NRC'S HANDOUT

ON WOLF CREEK GENERATING STATION

REQUEST FOR ADDITIONAL INFORMATION

TECHNICAL SPECIFICATION AMENDMENT
STEAM GENERATOR TUBE INSPECTIONS WITHIN TUBESHEET
TAC NO. MD0197

Loss Coefficient versus Contact Pressure (Combined Model F and Model D5)

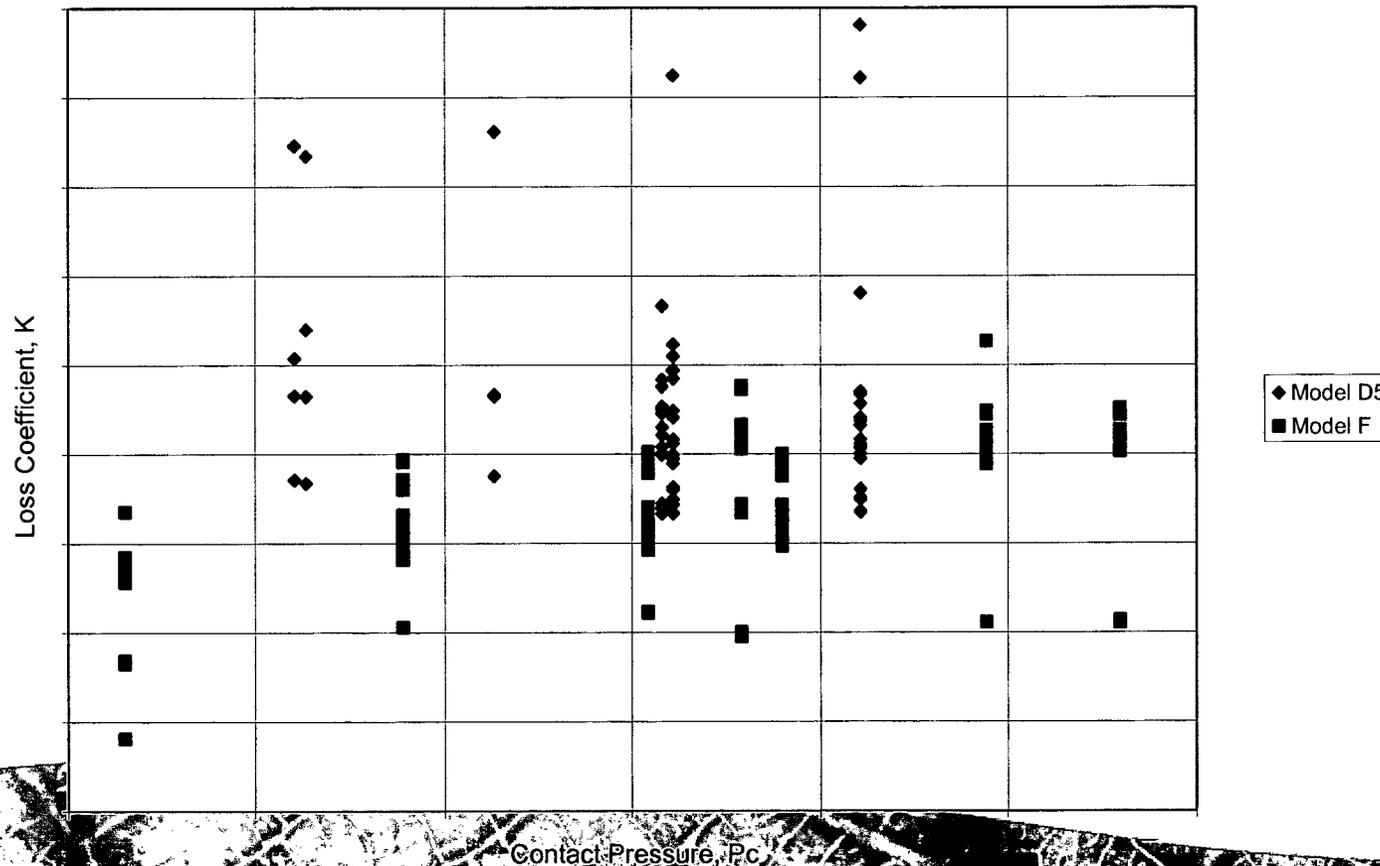
12. Figure 13 of Reference 2, Enclosure I contains additional loss coefficient data from previous leak test results not from the crevice pressure study in the white paper. Provide a figure showing all individual data points from which Figure 13 was developed. Describe the specific applied pressure differentials from the crevice pressure study used to calculate the contact pressure for each data point.

- The data supporting Figure 13 is provided below:

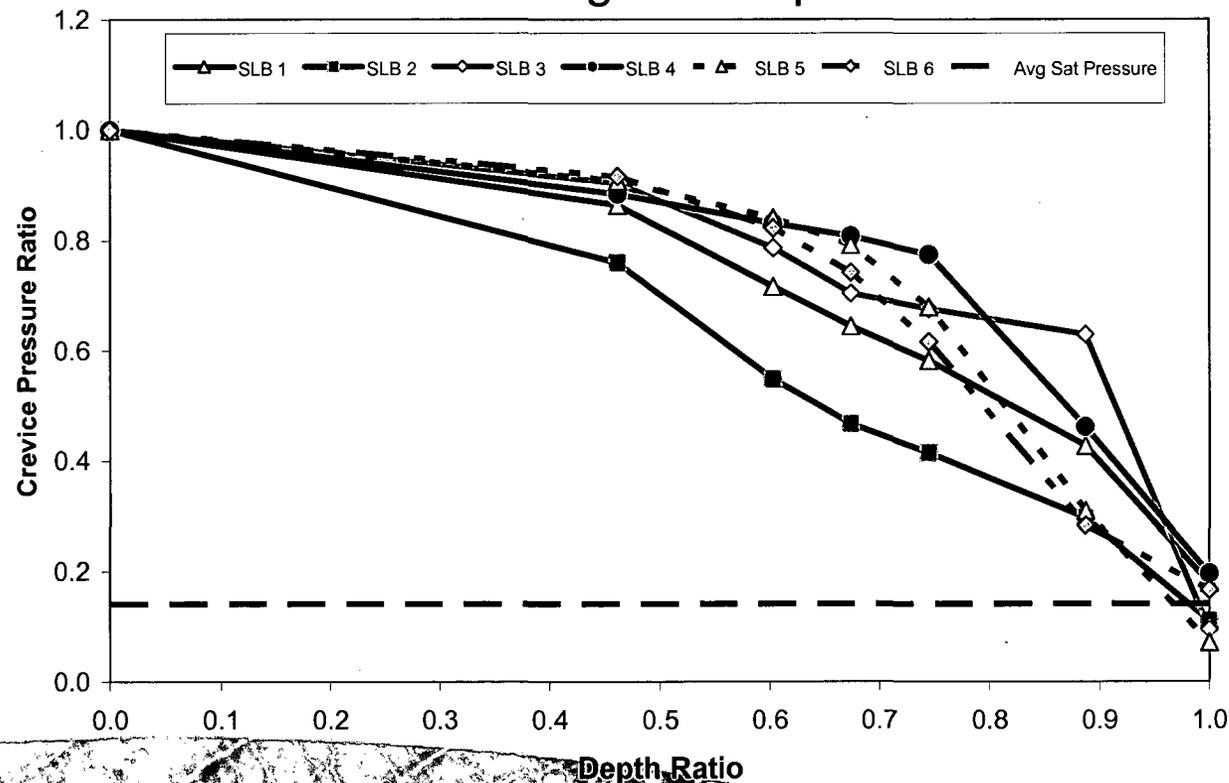
20. Reference 2, Enclosure 1, Attachment 1 - The pressure tap locations in Figure 2 are different from those shown in Figure 3. Discuss and explain this difference or provide corrected figures.

- The ordinate values, the horizontal axis, in Figure 2 of the White Paper are correct. The ordinate values used in the original Figure 3 were incorrect. The revised version of Figure 3 is provided below.

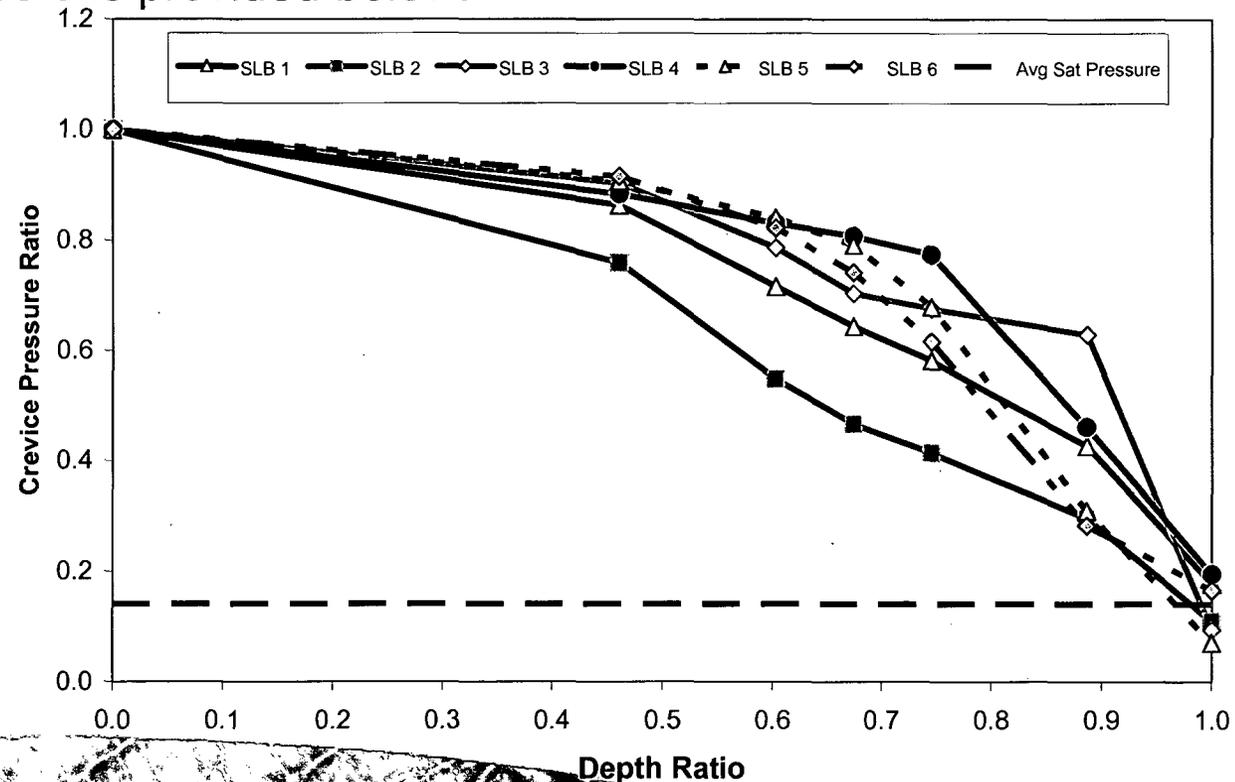
22. Reference 2, Enclosure 1, Attachment 1 - Figure 3 refers to tests labeled SLB 9 and SLB 10 which are not listed in Table 2. Discuss and explain this, or provide a revised Table 2 and Figure 3 showing all test results.

- The White Paper will be revised to correct any typos in the text or figures.
- The data in Table 2 is correct.
- A revised Figure 3 is provided below.
